BOARD OF ADJUSTMENT STAFF REPORT

File No. ZBA18-0081

1760 Cleveland Road - Dock/Boat Lift

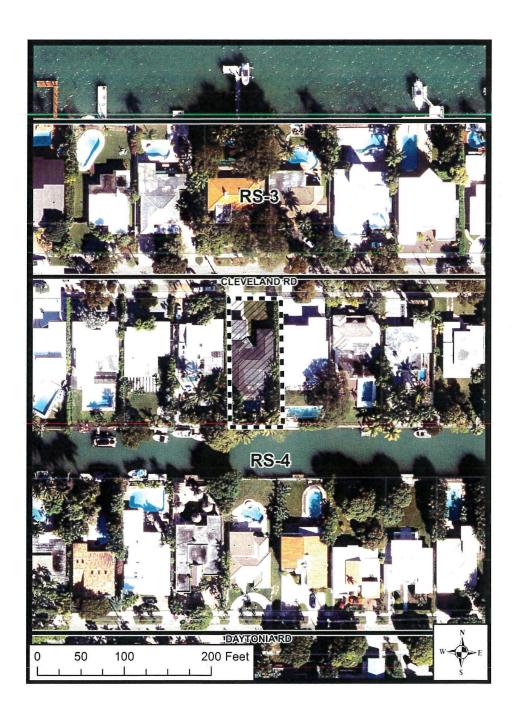
The applicant is proposing to install a new boatlift and to legalize an existing dock with a nonconforming side yard setback. The new boatlift exceeds the maximum projection allowed into the waterway and a variance is being requested.

The Code restricts the projection of marine structures into the waterway with a width less than 100' to a maximum of 10% of the width of the canal. It has been determined that the proposed location and configuration is the most appropriate to allow the boatlift to meet the County's required 4' minimum water depth. There are other docks and boat lifts installed along the canal; however, staff was unable to find permits or approval for these similar marine structures exceeding the maximum projection within the surrounding properties. As the requested variance is triggered by the existing conditions of the waterway, and the minimum water depth requirements of RER, staff has concluded that the hardship and practical difficulty criteria have been satisfied and recommends approval of variance #1.

Staff is not supportive of variance #2, as there are no specific site constraints that make the existing encroachment necessary. The fact that the existing dock existed prior to the applicants purchase of the property does not constitute a Practical Difficulty and Hardship.

In view of the foregoing analysis, staff recommends <u>denial</u> of variance request #2, and <u>approval</u> of variance request #1, subject to the conditions enumerated in the attached Draft Order.
